Informal document GRB-60-18
(60th GRB, 1-3 September 2014,
agenda item 4 (a))

**Proposal for the 03 series of amendments to Regulation No. 51:
modifications to ECE/TRANS/WP.29/GRB/2014/5 adopted at
the 60th session of GRB**

The text reproduced below is based on ECE/TRANS/WP.29/GRB/2014/5 and shows, in a visible manner, amendments to the original proposal adopted at the 60th session of GRB and listed in Annex III to the report of the session ECE/TRANS/WP.29/GRB/58. The modifications to ECE/TRANS/WP.29/GRB/2014/5 are marked in blue underline for new or blue strikethrough for deleted characters.

Model A
(See paragraph 5.4. of this Regulation)

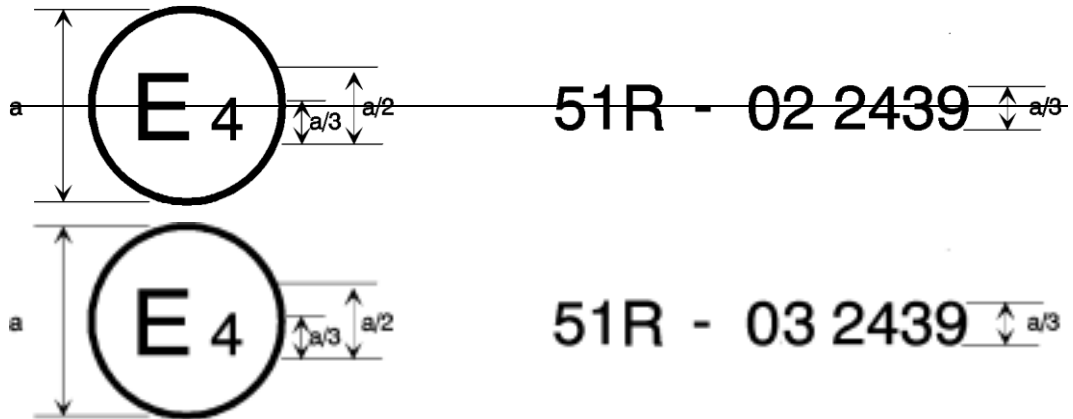
The above approval mark affixed to a vehicle shows that the vehicle type concerned has, with regard to its noise emission, been approved in the Netherlands (E 4) pursuant to **Regulation** No. 51 under approval No. 0232439.

The first two digits of the approval number indicate that **Regulation** No. 51 already included the 023 series of amendments when the approval was granted.
